ORIGINATION FORM

Proposed Revisions to a Standard Plans Index
(Please provide all information — Incomplete forms will be returned)

Index Number: 515-022

Index Title: Pedestrian/Bicycle Bullet Railing Details

| LAST REVISION 11/01/17 | REVISION | DESCRIPTION: | | FY 2020-21 STANDARD PLANS | PEDESTRIAN/BICYCLE BULLET RAILING DETAILS | INDEX 515-022 | SHEET 3 of 3 |

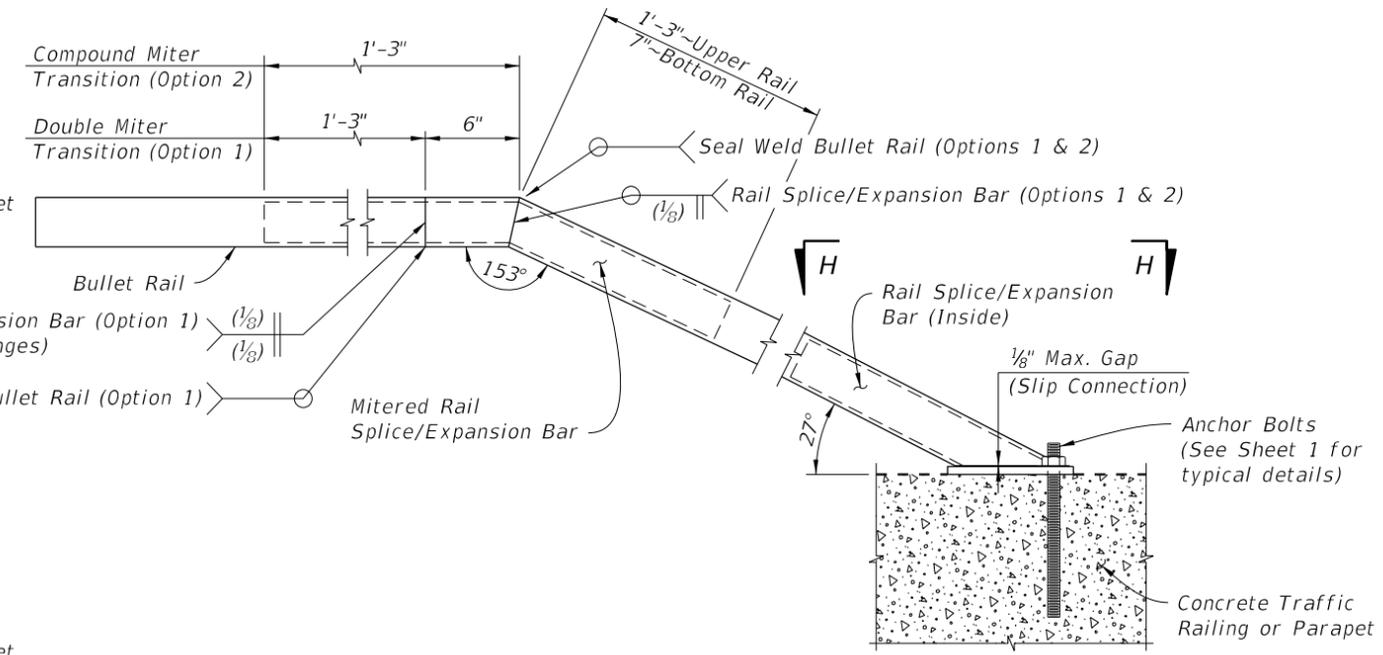
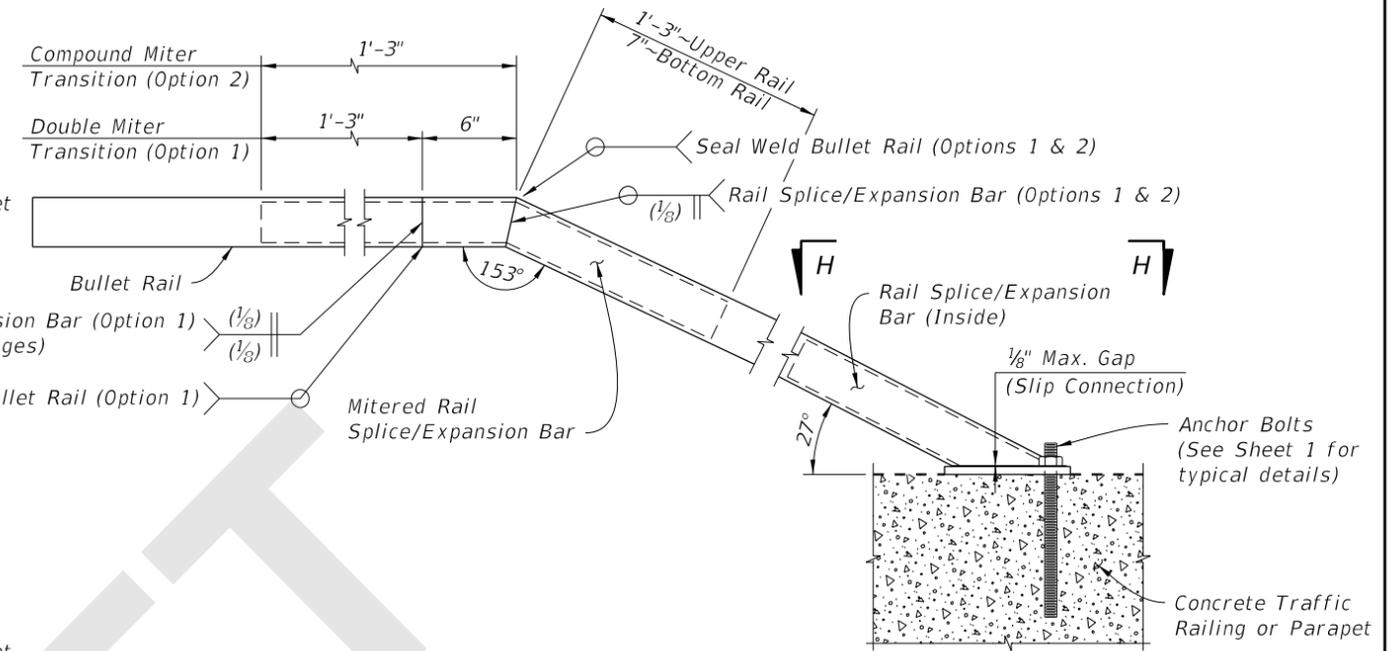
Added Note 3D

Added clarity to the types of anchor bolts applicable

D. Anchor Bolts: Galvanized ASTM A307 Grade 36 Hex Head. ASTM 1554 Grade 55 Threaded Rods for Adhesive Anchors

D. Anchor Bolts: Galvanized ASTM A307 Grade 36 Hex Head. Galvanized ASTM 1554 Grade 55 Threaded rods for Adhesive Anchors.
- Layout:
 - Posts shall be uniformly spaced with reasonable consistency.
